Proposed Bantry Peace Park Playground,  
Glengarriff Road, Bantry

STAGE 1 & 2 ROAD SAFETY AUDIT

<b>Client</b>	Cork County Council
<b>Project Title</b>	Proposed Bantry Peace Park Playground
<b>Document Title</b>	Stage 1 & 2 Road Safety Audit
<b>Document No.</b>	23030RS-Doc01
<b>Job No.</b>	23030RS

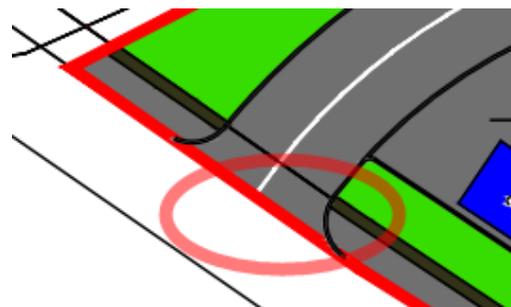
There is an existing ESB network pole with a transformer on it behind the stone boundary wall in the middle of the proposed car park. See photo and sketch below. This ESB pole has not been indicated for relocation on the design layout drawings. If left in

position the pole and cable stays would obstruct at least 2 spaces and constitute an obstructing hazard for road users manoeuvring their vehicles in the car park, potentially resulting in evasion collisions with opposing vehicles or with the pole itself. See photos A2 and A5. And there is a potential live electricity proximity danger also for pedestrians.

There was no lighting design submitted for the proposed development for review as part of this Audit. While street lighting may not be required for the children’s playground or associated car park, the entrance to the car park may require lighting as it is in close proximity to a national secondary road junction. Also as highlighted in problems 2.1 and 2.2 above, the existing street lighting poles may need to be relocated and consequently a new lighting design would be required.

Inadequate lighting may lead to collisions between pedestrians and vehicles using the proposed car park at night-time or during poor weather in winter time.

Consider relocating this pole a safe distance from the car park vehicle and pedestrian circulation area.

Consider the need for street lighting for this scheme. At a minimum carry out a design check of the exterior lighting requirements.

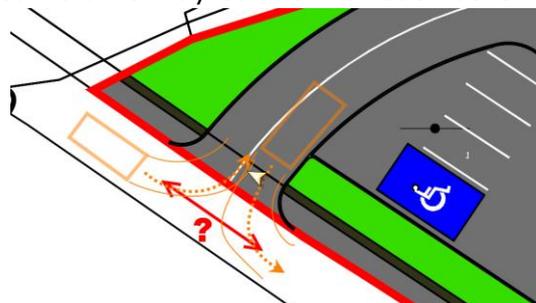
The entrance width to the car park access appears very narrow at the bell mouth. There is a risk that vehicles entering and exiting at the same time may collide with each other.

Consider using a swept path analysis tool for the Design Vehicle such that the optimal entry/exit width can be provided.

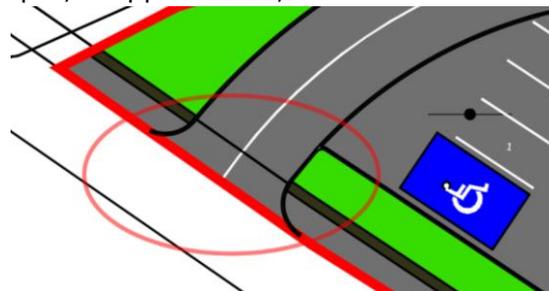
No tactile paving has been shown to be installed at the proposed entrance into the car park. Neither is there any reference made to “ramps”, dropped kerbs, dished footpaths or raised entry treatment at the junction. Failure to provide an appropriate pedestrian/vehicle interface with tactile paving may lead to collisions between visually impaired pedestrians and vehicles entering and exiting the proposed car park.

Provide the appropriate tactile paving at both sides of the development entry/exit point in accordance with the relevant guidelines. Further details should also be provided regarding proposals for ramps, drop kerbs etc. It may be more appropriate to provide a raised entry treatment across the entry/exit lanes as would be more comfortable for wheelchair users and the mobility impaired passing by on the footpath.
